# Service Bulletin

Bulletin No.: 17-NA-265

**Subject: Flutter or Thump Noise from Rear of Vehicle**

4849172

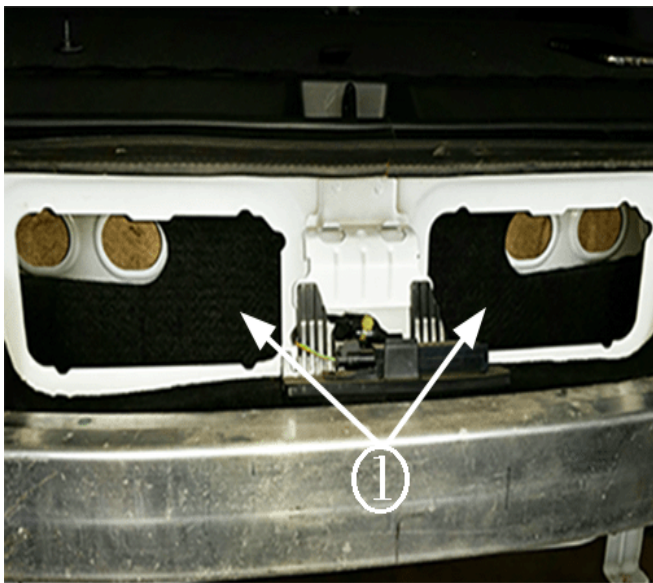
1. Remove the rear fascia and both original rear pressure relief valves (PRVs) (1). Refer to the appropriate *Body Pressure Relief Valve Replacement* procedure in SI.

4849174

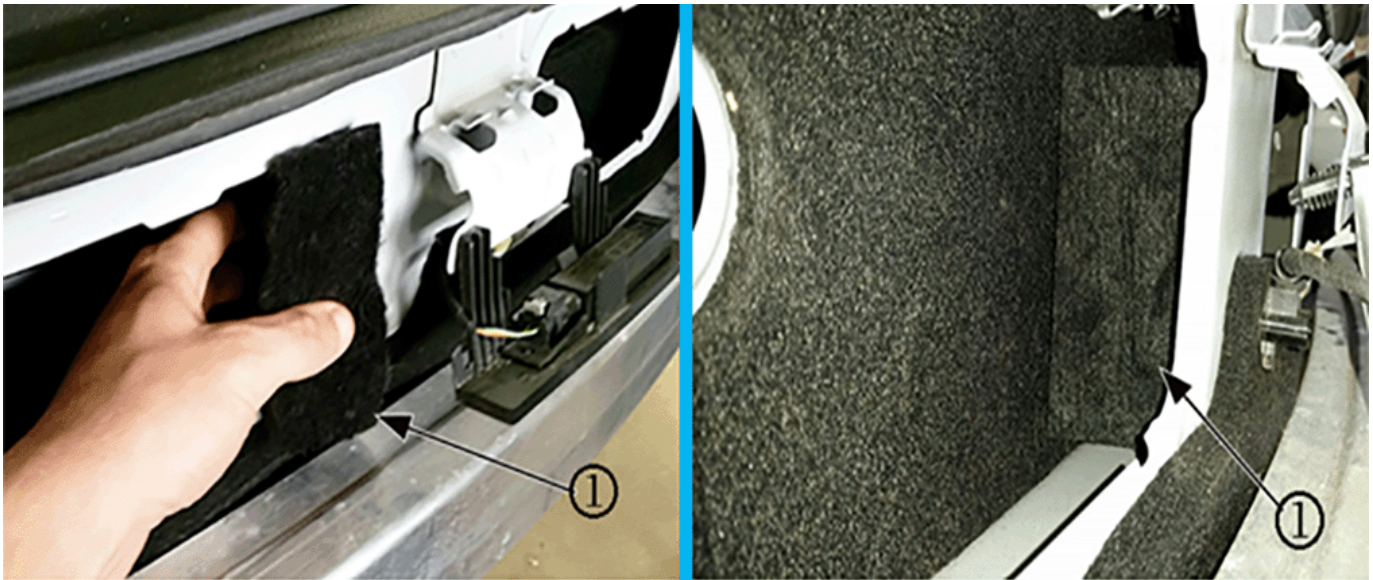
- 3.1. Slide the insulator panel (1) into one of the PRV openings.

- Important:** Ensure that the insulator panel is centered and DOES NOT BLOCK any of the holes in the body.
- 3.2. Center the insulator along the back side of the chamber.
  - 3.3. Tuck the outside edges of the panel into the corners.

4849178

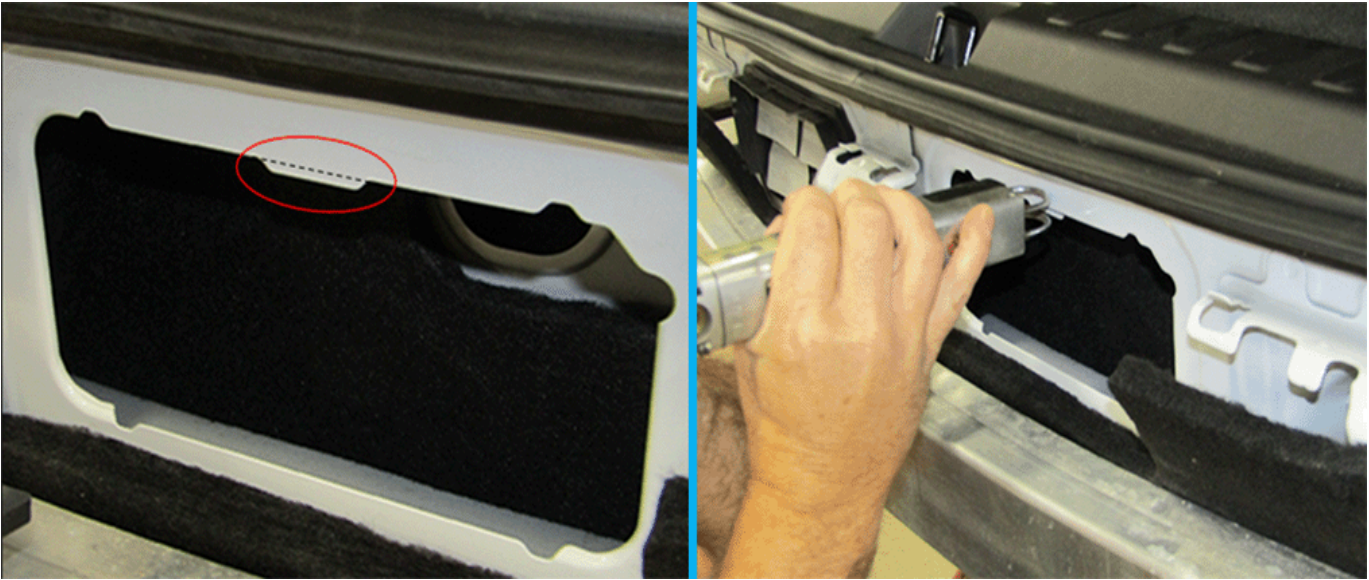
4. Install the acoustic insulator block (1) in the middle of the chamber, between both PRVs.

4886516

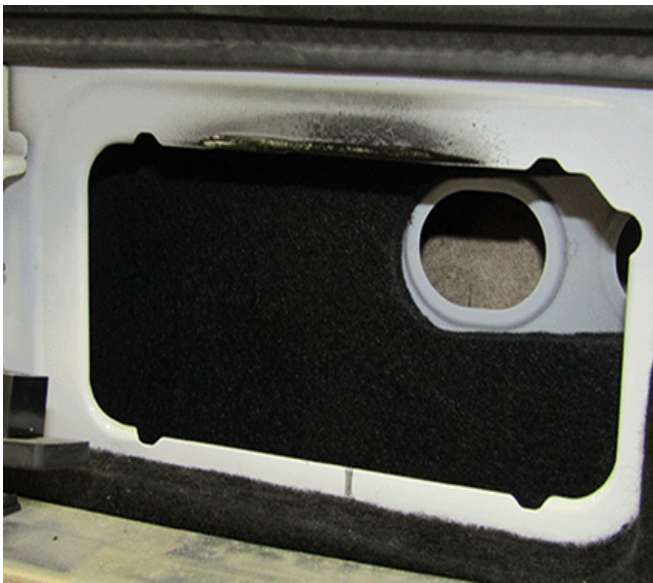
**Note:** The sheet metal tabs should be ground/cut off to be flush with the top edge of the opening.

- 5.1. Using a die grinder or air body saw, remove the sheet metal tab located at the top of EACH PRV opening.

4886517

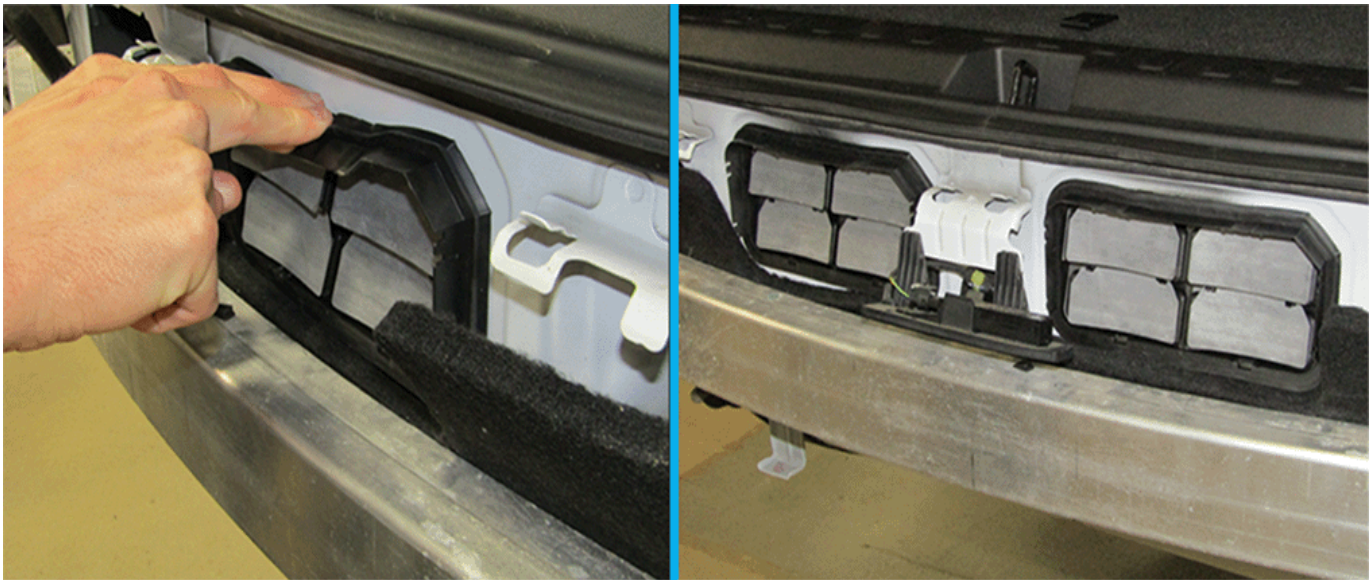
- 5.2. Apply Lloyds Kryptonite Metal Treatment P/N 36502 Life Long Rust Protection (14 ounce aerosol), or equivalent rust inhibitor, to the bare metal areas.

4886519

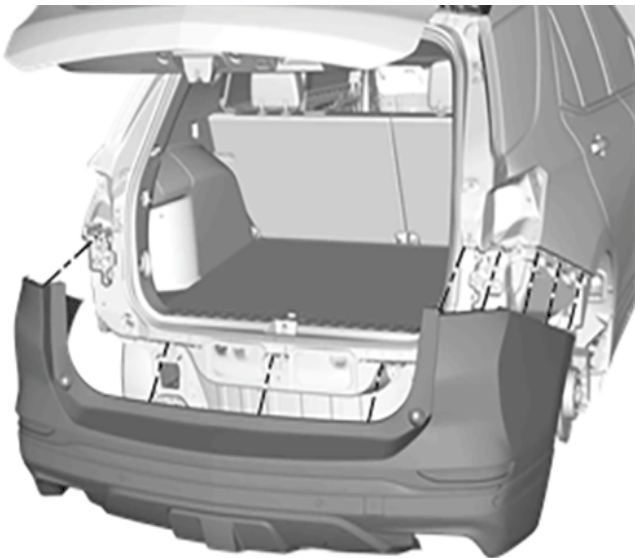
5.3. Seat the bottom of each PRV into the sheet metal opening, then snap into place at the top.
